**SITE PLAN REVIEW
PUBLIC WORKS DEPARTMENT**

21-03 Arbutus Street Access Driveway

City of Middletown, CT
 Public Works Engineering Division
 SHOWING
 Intersection Vertical Design

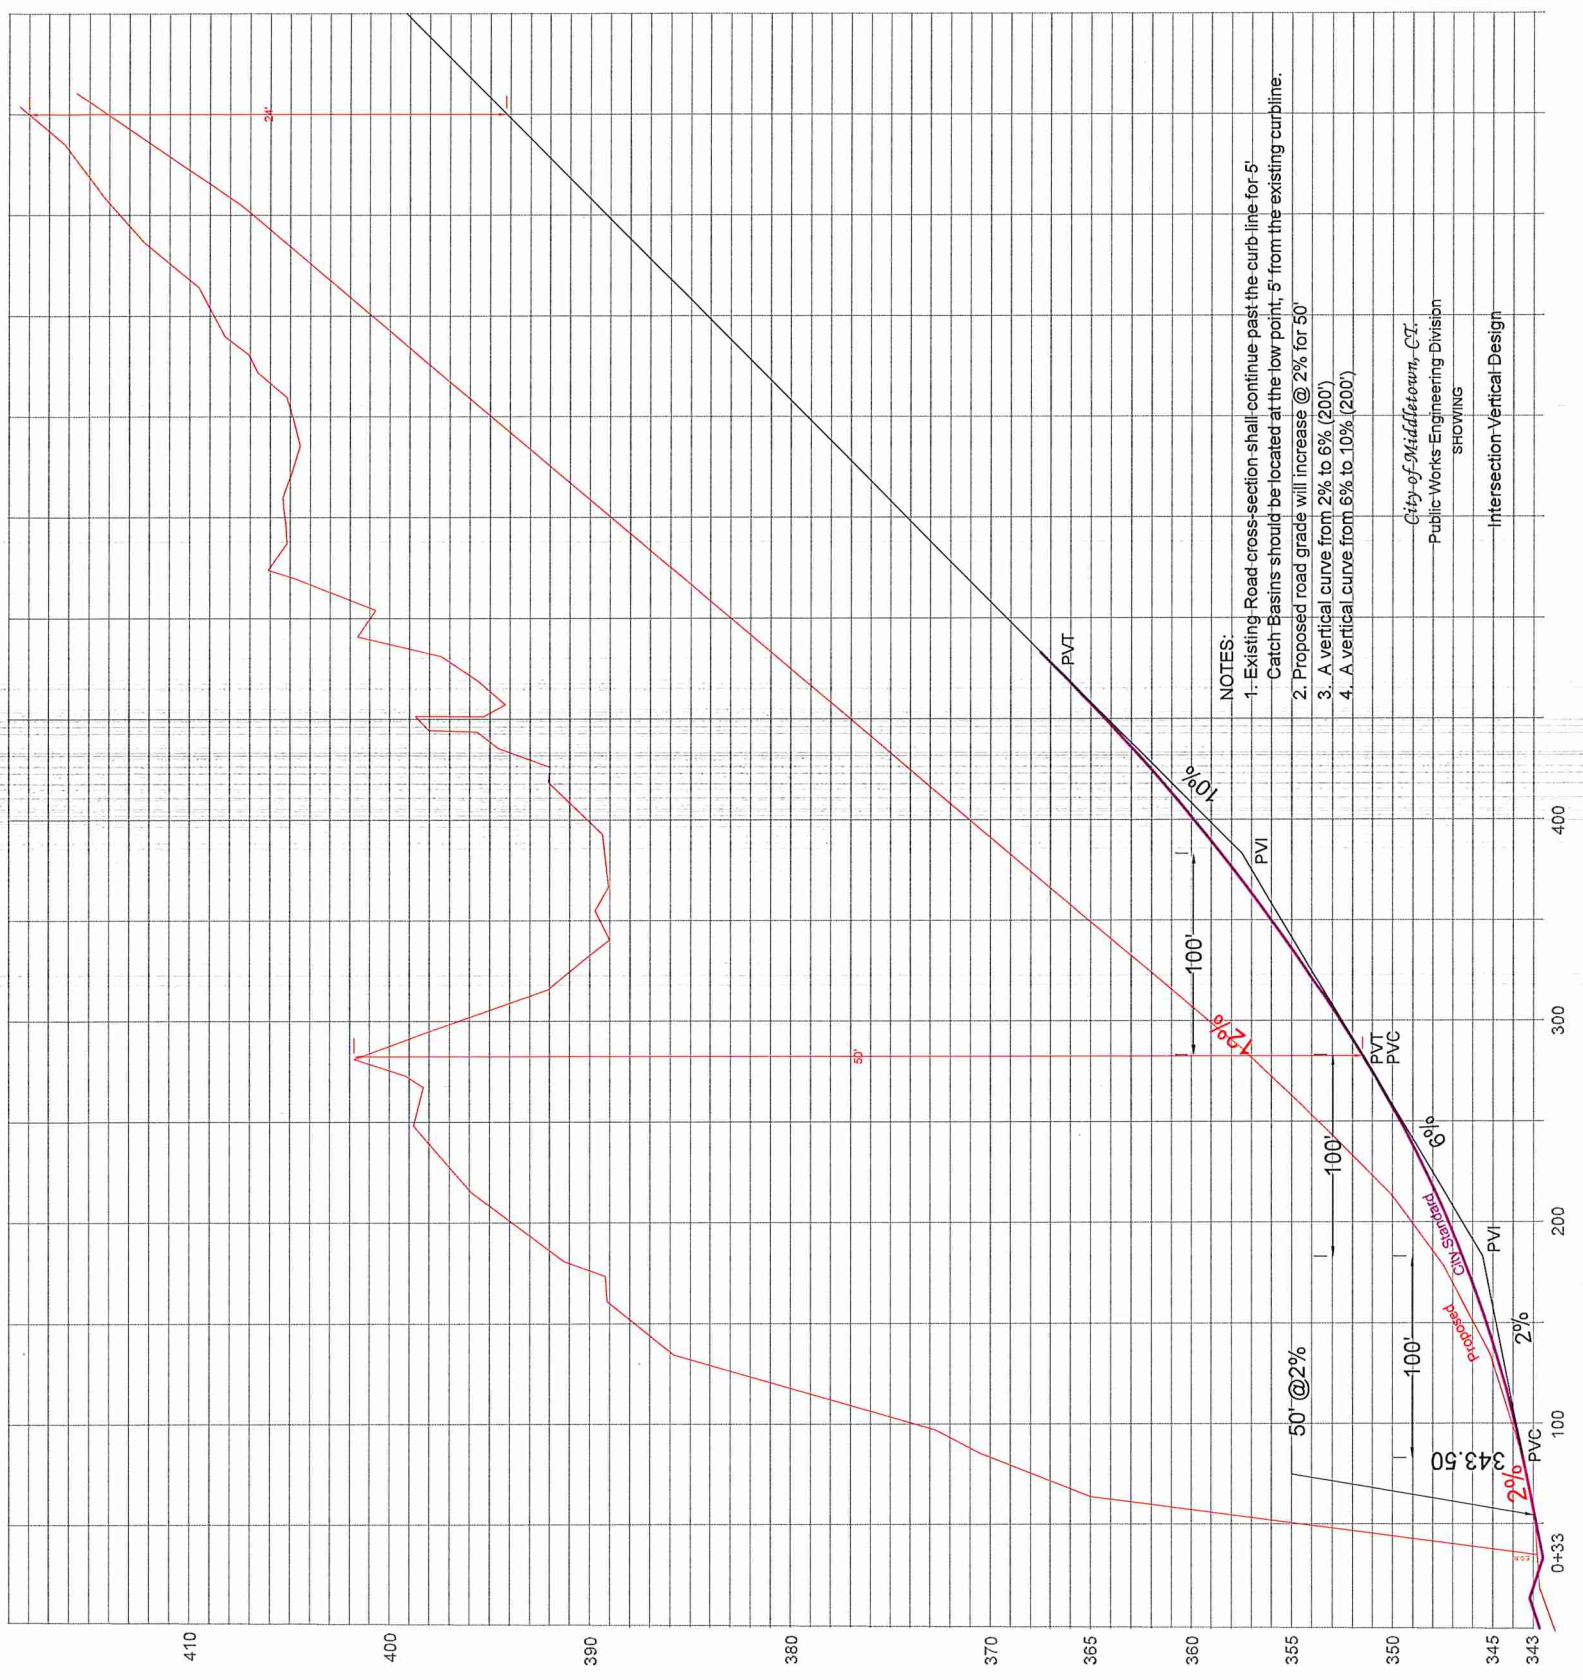
The profile shows the driveway rising at 12% grade, then increasing to 15%. Our maximum driveway grade is 12%.

Attached is the profile showing the maximum grade of a street. It is clear that using the 10% maximum street grade, the driveway will never reach the existing surface grade at the top. This driveway would need to be lowered as much as 15 additional feet to be able to be considered as a City street.

Having a steep slope and surfaced with processed stone, the catch basins will have a tendency to fill up with stone and not function adequately. This can cause erosion or icing on the driveway. Emergency services might find it difficult to access under those conditions.
